U.S. Department of the Interior BUREAU OF LAND MANAGEMENT Sundry Print Report

Well Name: CHRISTOPHER 31 FED Well Location: T23S / R31E / SEC 31 / County or Parish/State: EDDY /

Notice of Intent

Notice of Intent to PA Christopher 31 Fed #002 30-015-617 OXY USA INC.

PROPOSED WELLBORE

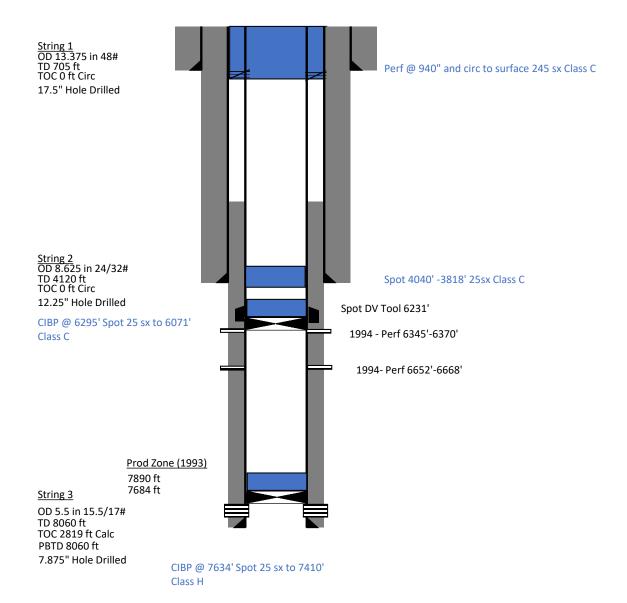
Sundry ID	2684600	1	-		ı	
Plug Type	Тор	Bottom	Length	Tag	Sacks	Notes
Surface Plug	0.00			Tag/Verify		
				If solid		
				base no		
				need to		
				Tag		
				(CIBP		
				present		
				and/or		
				Mechanic		
				al Integrity		
				Test), If		
				Perf &		
				Sqz then		
				Tag, Leak		
				Test all		
				CIBP if no		
				Open		
Freeh Weter @ 400	246.00	450.00	104.00	Perforatio		
Fresh Water @ 400	346.00					
Shoe Plug	647.95			Tag/Verify Tag/Verify		
Top of Salt @ 890	831.10					
Base of Salt @ 3868	3779.32	3918.00		Tag/Verify If solid		
				base no		
				need to		
				Tag (CIBP

•		
				present and/or		
				Mechanic		
				al Integrity		
				Test), If		
				Perf &		
				Sqz then		
				Tag, Leak		
				Test all		
				CIBP if no		
Dalaurana @ 4446	4000.00	4400.00	444.40	Open		
Delaware @ 4118	4026.82	4168.00	141.18	Perforatio		Snot from 4170! to
						Spot from 4170' to 2819'. WOC and
						Tag. Perf and
						O .
						Squeeze at 2819'.
						(In/Out) Verify at Surface. 665 sx
Chao Dive	4000.00	4470.00	444.00	Tog/\/orif.	127, 665	
Shoe Plug	4028.80			Tag/Verify		CidSS C.
DV tool plug	6118.69			Tag/Verify		
Perforations Plug (If No CIBP)	6256.30	6420.00	163.70	Tag/Verify

If solid	
			base no	
			need to	
			Tag	
			(CIBP	
			present	
			and/or	
			Mechanic	
			al Integrity	
			Test), If	
			Perf &	
			Sqz then	C-+ CIDD -+ C00El
			Tag, Leak	Set CIBP at 6295'.
			Test all	Spot from 6295' to
			CIBP if no	6071'. Leak Test
			Open	CIBP. Class C.
CIBP Plug	6260.00		35.00 Perforatio	WOC and Tag.
Perforations Plug (If No CIBP)	6551.32	6718.00	166.68 Tag/Verify	
			If solid	
			base no	
			need to	
			Tag	
			(CIBP	
			present	
			and/or	
			Mechanic	
			al Integrity	
			Test), If	
			Perf &	
			Sqz then	
			Tag, Leak	0 4 0100 4 700 41
			Test all	Set CIBP at 7634'.
			CIBP if no	Spot from 7634' to
			Open	7410'. Class H.
CIBP Plug	7599.00		35.00 Perforatio	WOC and Tag.
Perforations Plug (If No CIBP)	7634.00	7940.00		
			If solid	
			base no	
			need to	
			Tag	
			(CIBP	
			present	
			and/or	
			Mechanic	
			al Integrity	
			Test), If	
			Perf &	
			Sqz then	
			Tag, Leak	
			Tag, Leak Test all	
			CIBP if no

Open	
Bonesprings @ 7949 Shoe Plug	7819.51	7999.00	179.49 Perforatio	
IShaa Diya	7929.40	8110.00	180.60 Tag/Verify

See COA for Requirements
